DEVELOPMENT ASSESSMENT REPORT				
Application No.	MOD/2021/0142			
Address	307 Nelson Street ANNANDALE NSW 2038			
Proposal	Section 4.55(1A) Modification of Development Consent DA/2020/0627 which approved new dwellings and associated works, seeking various changes, including to delete various conditions, including required design change conditions to the front of the house and that require the lowering of the pool and rear deck levels, and various tree protection conditions			
Date of Lodgement	20 April 2021			
Applicant	Candella Properties Pty Ltd			
Owner	Mr Wallace H Chu Ms Sylvia A Attard			
Number of Submissions	Initial: 10			
Value of works	\$1,093,200.00			
Reason for determination at Planning Panel	Number of submissions exceeds Officer delegations and the proposed modifications seek to delete design change conditions imposed by Inner West Planning Panel			
Main Issues	<ul style="list-style-type: none"> • Impact to Trees on the adjoining property • Impact to heritage conservation area • Amenity impacts to adjoining properties

Recommendation	Part Approval			
Attachment A	Recommended conditions of consent			
Attachment B	Original conditions of consent			
Attachment C	Plans of

01 PLAN - FIRST FLOOR
SCALE 1:100 @ A1 (1:100 @ A1)

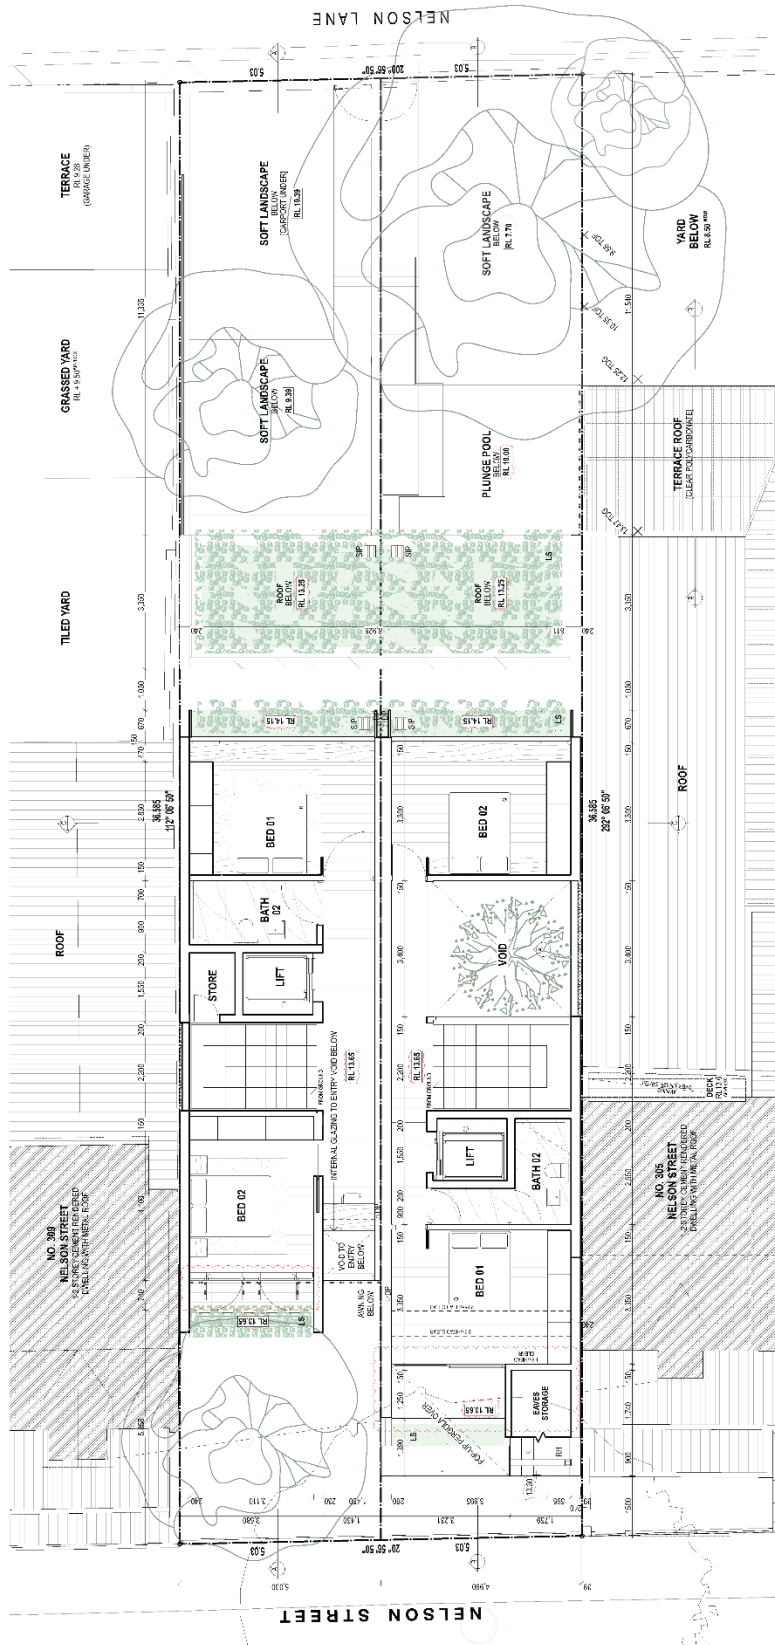
Comment: The Heritage Advice states *“The proposed recessed door and windows to the front elevation of No.307A Nelson Street looks at a modern interpretation of the Victorian verandah and balcony recesses to provide articulation, texture and shadow to the elevation.”*

1. Amended plans are to be submitted incorporating the following amendments:
 - a. The recessed door and windows to the front façade of dwelling 307A are to be deleted and redesigned so they sit within a simple front façade, and as part of this simplification, the eaves storage at the first floor is to be deleted.

01 ELEVATION - SOUTH
SCALE 1:50 @ A11.11.16 @ AS

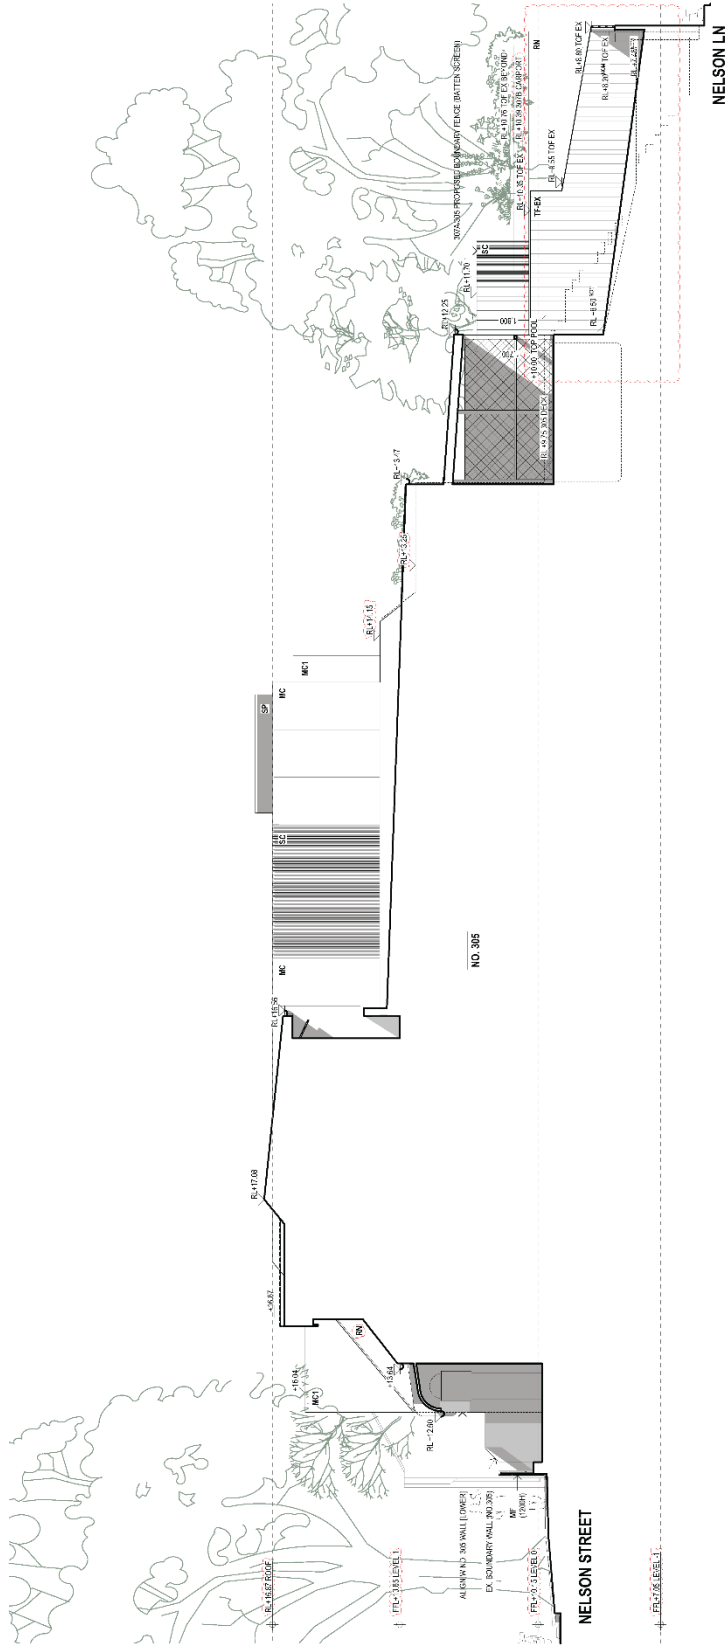
- c. *The sloping glass skylights to the east elevation of the dwellings is to be deleted. If skylights are required, they are to sit flush with the rear roof plane.*

The skylights will be visible from the rear elevation, from Nelson Lane. As stated in the original heritage referral for the DA, the skylights are not supported and are to be deleted as they are not characteristic of the character within the HCA. If skylights are required, they are to sit flush with the rear roof plane. The deletion of this condition is not supported.

Comment: The solar panels are proposed to be located to the rear of the dwellings, which is acceptable. However, they are proposed to sit at an angle from the roof plane. This condition is to remain so the solar panels are installed so they sit flush to the roof plane as they will be visible from Nelson Lane.

- c. The sloping glass skylights to the east elevation of the dwellings is to be deleted. If skylights are required, they are to sit flush with the rear roof plane.
